## SEWAGE DISPOSAL TESTING

PROPERTY OWNER Robert M. Warfield & wife

# PERMIT

SEWAGE DISPOSAL SYSTEM

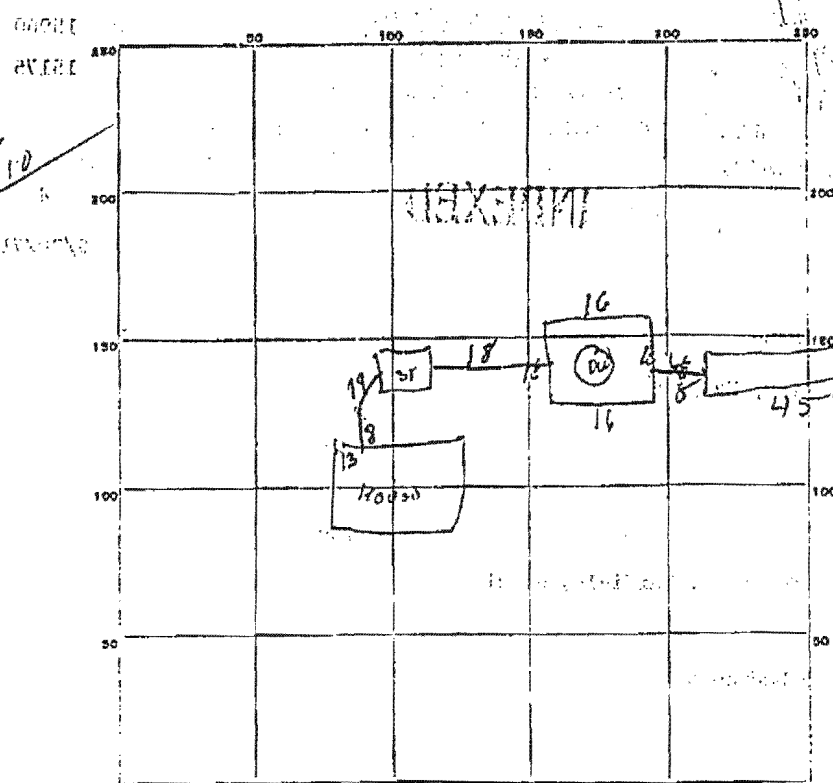
REMARKS 5-20-71 - need 5 ft solid pipe of dry well - then trench across  
all dirt must be removed from under tile - tile must not be clean gravel.  
tile must be spaced 1/2 to 3/4 inch apart - joints to be covered with 1/2 inch tan paper.  
slope in trench must be 1/2" per 40 ft. - inside of gravel  
over pipe then roofing paper - need 8" black pipe on septic tank  
to grade level - pipe from foundation to tank + from tank to dry well  
must be installed

call for final when all of above is done
